Corrigendum - 2 dated 19/12/2025 to CPC Tender No. BHEL/CPC/ RTP/EPC_AHP_CHP/26/051

Work Description - EPC PACKAGE FOR ASH HANDLING PLANT, COAL HANDLING PLANT and MILL REJECT HANDLING SYSTEM AT DVC RAGHUNATHPUR TPS PHASE-II (2X660MW) STEAM GENERATOR (SG) ISLAND PACKAGE.

A) Some of the Bidders sought clarifications in regard to the published tender specification. The clarifications issued by BHEL are as below;

MRHS Flow Diagram

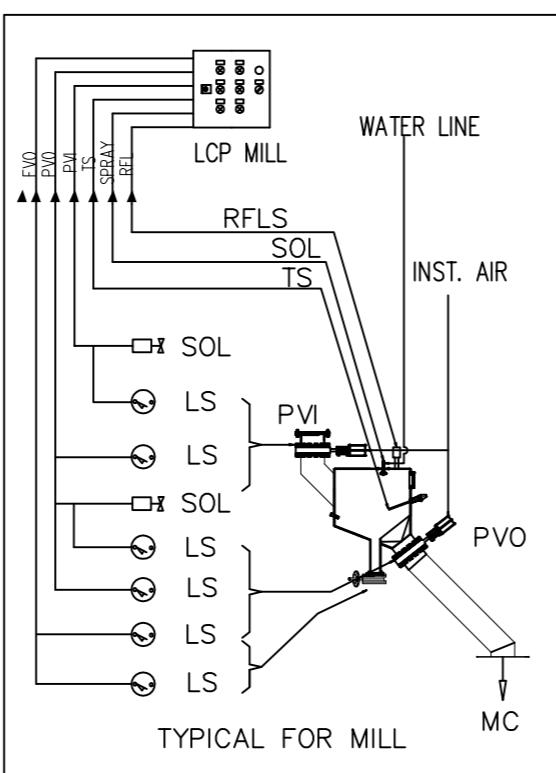
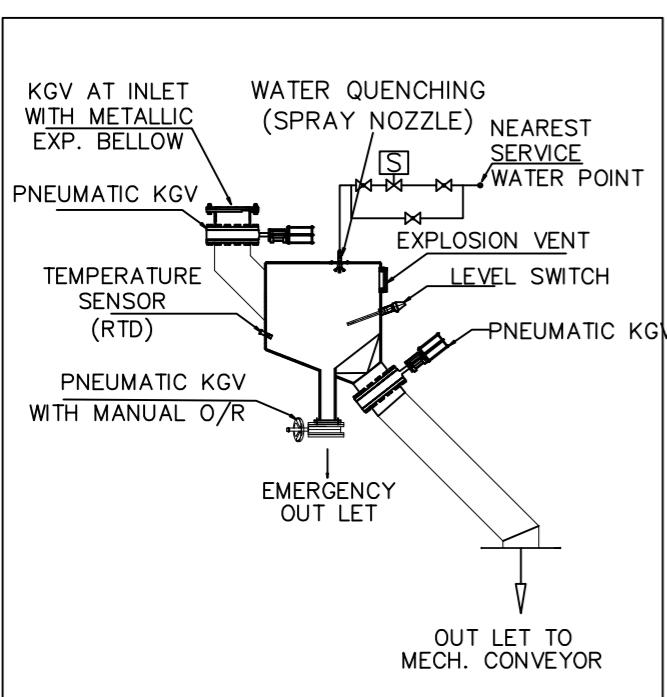
SL. NO.	Reference Clause	Specification	Bidder's Query	BHEL's Clarification
7	XXXX-001A-POM-A-027 R (0)	SINGLE LINE FLOW DIAGRAM OF FLY ASH HANDLING SYSTEM (VACUUM SYSTEM)	<p>As per drawing, 10 Nos coarse fly ash and 2 Nos fine fly ash pipe is connected to each main fly ash silo.</p> <p>No of pipe connected to main fly ash silo shall be as follows: -</p> <ol style="list-style-type: none"> 1. From Buffer hopper 6Nos. / unit total 12 Nos for 2 units. 2. 4 Nos (2W+2S) pipe from below Coarse Fly Ash Hopper. 3. 2 Nos. (1W+1S) pipe from below Fine Fly Ash Hopper <p>Thus total No of pipe above fly Ash silo shall be 18Nos.</p> <p>Please Confirm.</p>	No. of ash pipe lines shall be as per system requirement. In case of vacuum conveying system, bidder's understanding is correct.
8	Annexure-18	Mill Reject Handling system	We have not found any flow diagram for MRHS system. We therefore request you to kindly provide the same for our better understanding.	Bidder to refer MRHS Flow Diagram attached along with this Corrigendum.

TITLE STEAM GENERATOR ISLAND PACKAGE
COAL CONVEYING IN MAIN PLANT

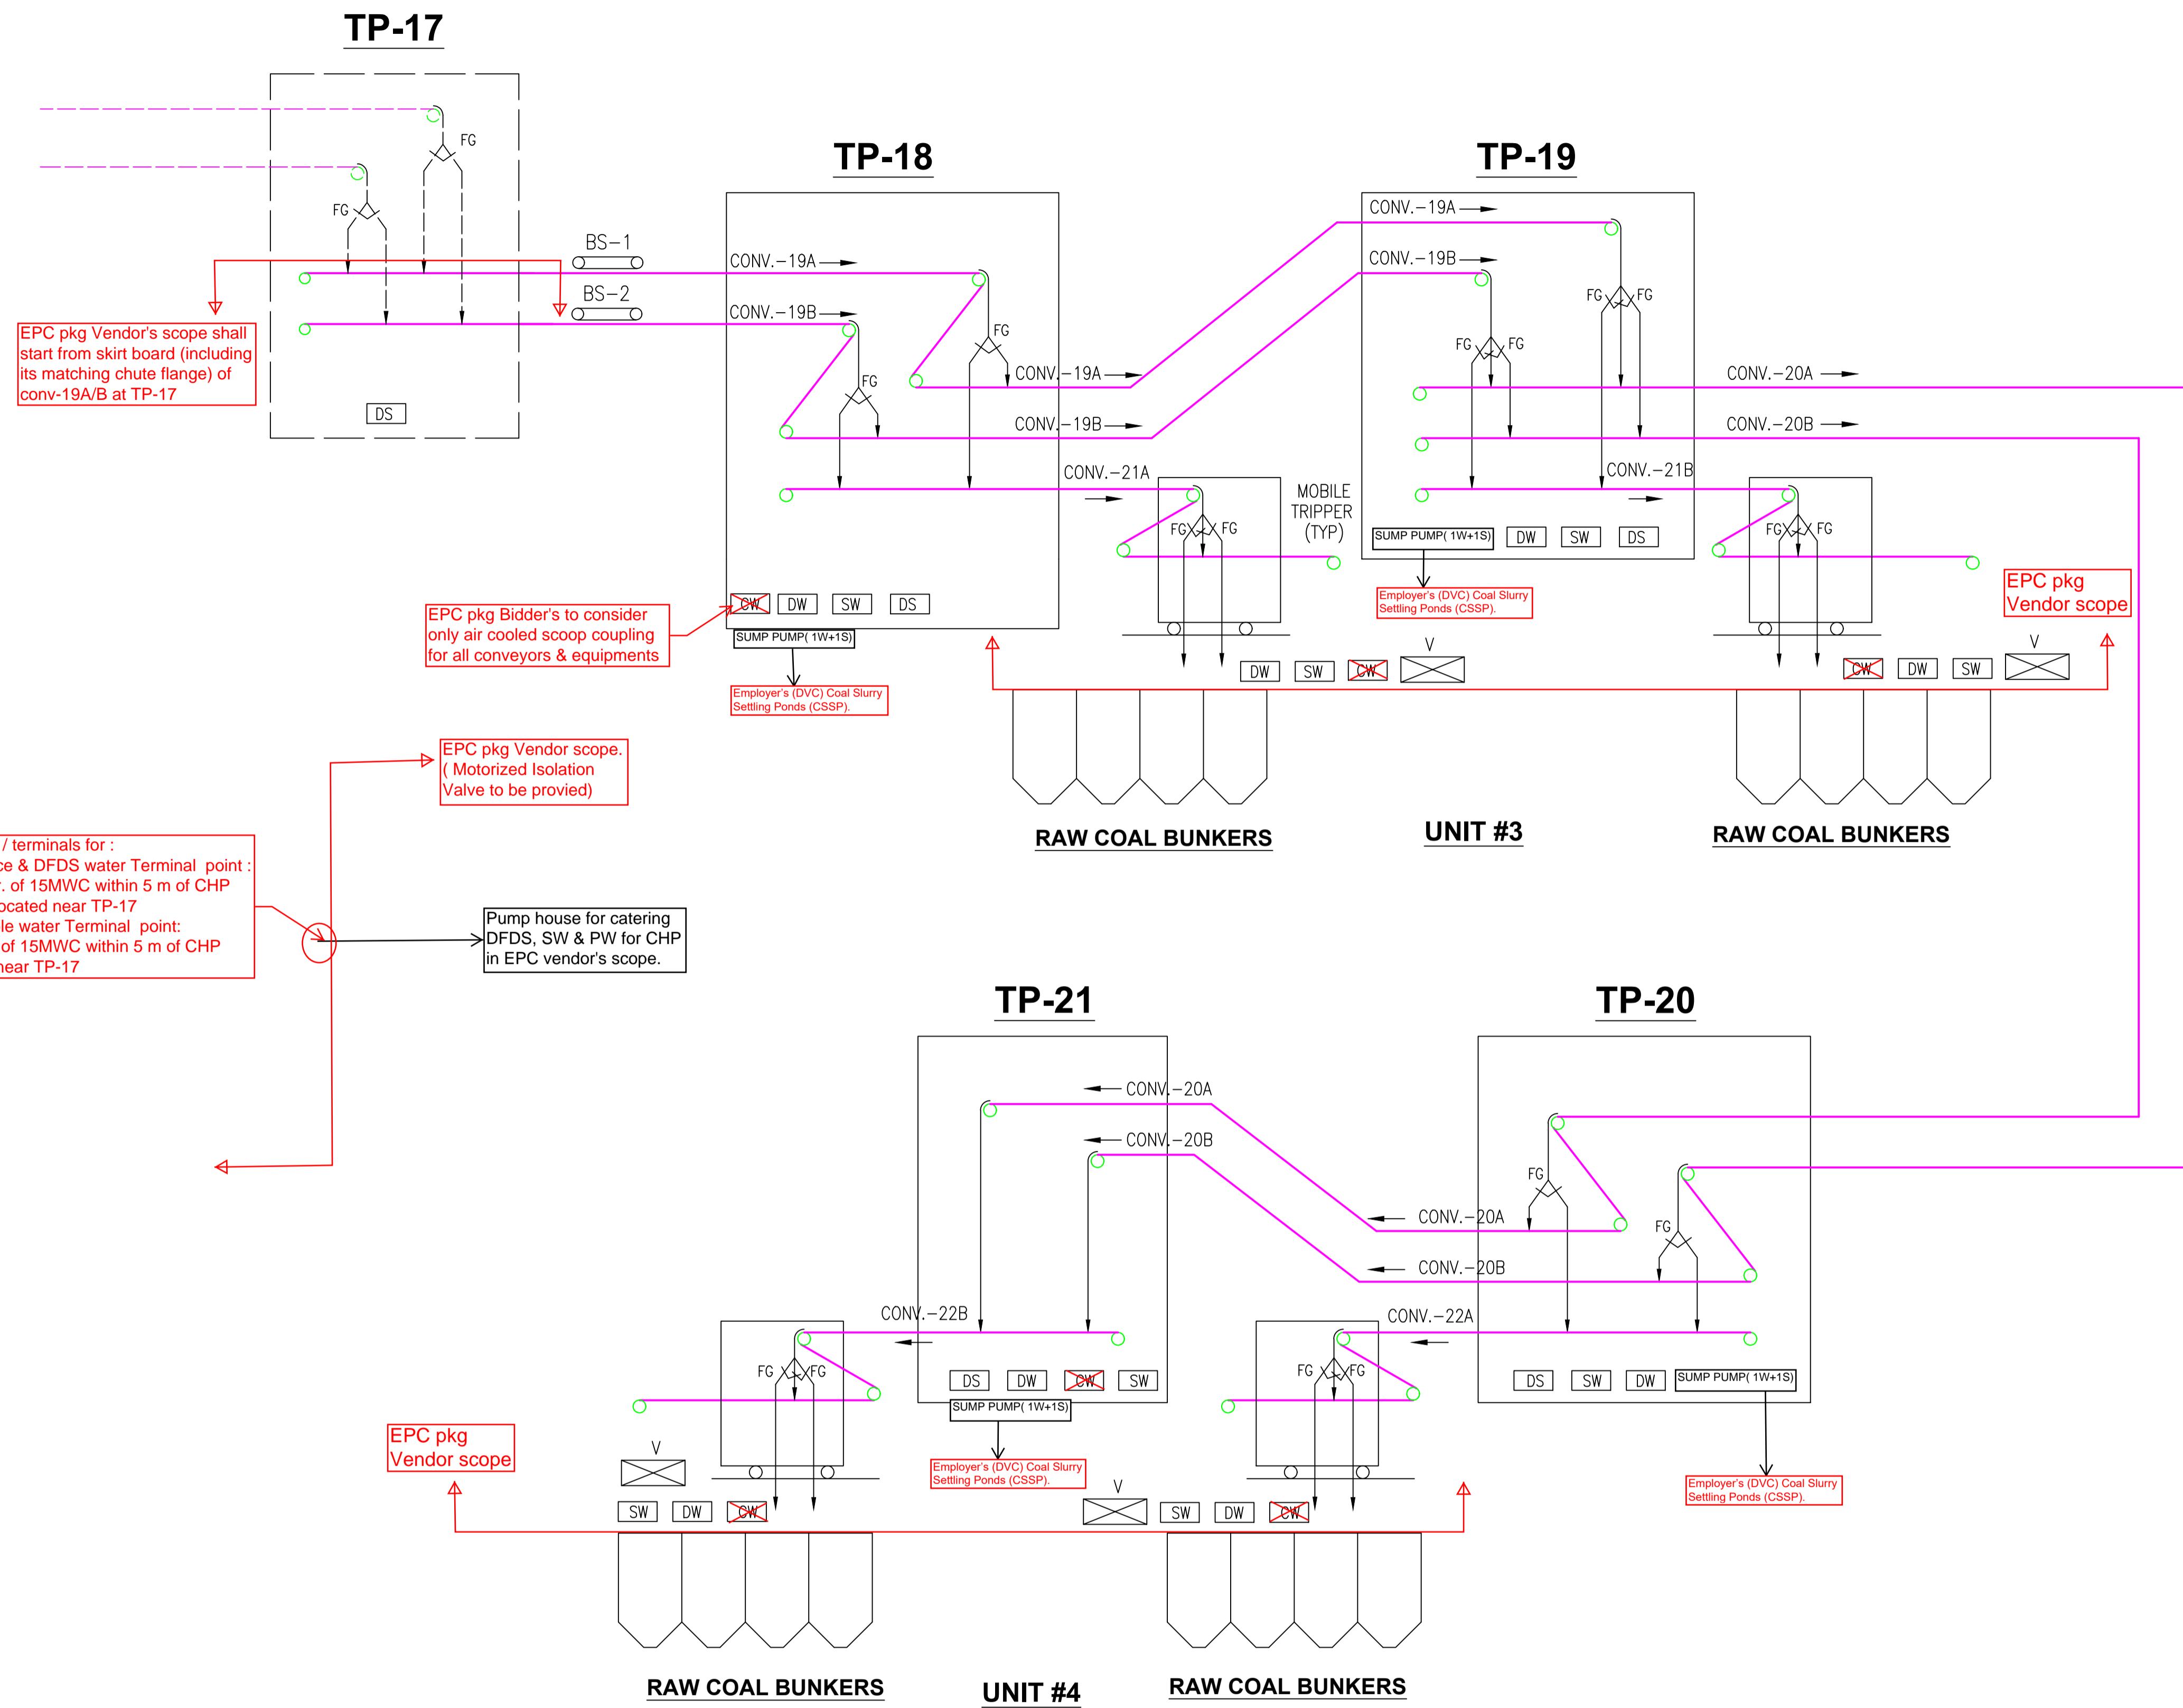
9	Technical Conditions Of Contract	Instrument Air Compressor.	We understand that IA compressor will be excluded from the present scope and the same shall be tapoff from the main Plant air compressor. However kindly confirm that any separate Instrument air is required in Silo area or not.	Specification is clear. Any other requirement for satisfactory operation/ completion of AHP system, shall be considered by the bidder in his scope.
10	Pre-Qualifying Requirements Cl. A Technical:	Bidder shall essentially meet all the Qualifying Requirements cited under. For the purpose of qualification, experience shall be reckoned as on 10.02.2025.	The tender published on 28.11.25 and the due date of submission is 15.12.25. For more no of competitive bidding the experience shall be from the due date of tender. Kindly look in to it.	Tender Conditions Shall Prevail
11	XXXX-999-POM-A-031 (SH-1) R0	LIME STONE FLOW DIAGRAM	We have not found any flow diagram for CHP for main plant system. We therefore request you to kindly provide the same for our better understanding.	Bidder to refer CHP Flow Diagram, attached along with this Corrigendum.

35	Single Line Diagram for Fly Ash Handling System	<p>As per the said Flow Diagram there are 01 Fly Ash Silos. But at the same time as per drawing there are 02 Nos. Fly Ash Silos.</p> 	Please confirm the final quantity of Fly Ash Silo & storage capacity of each to be considered	The quantity of Main silos is 3 Nos (including Fine fly ash silo)
36	Annexure -2-Scope matrix: Scope Matrix & terminal points for AHP & CHP EPC package		We request you kindly share the soft copy of the said document.	Bidder to refer to the documents attached as part of the tender document.
37	Annexure -2-Scope matrix: Scope Matrix & terminal points for	B) Coal Conveying System in the Main Plant	We request you kindly share the Flow Scheme of Coal Handling System for our reference.	Bidder to refer CHP flow Diagram, attached along with this Corrigendum.
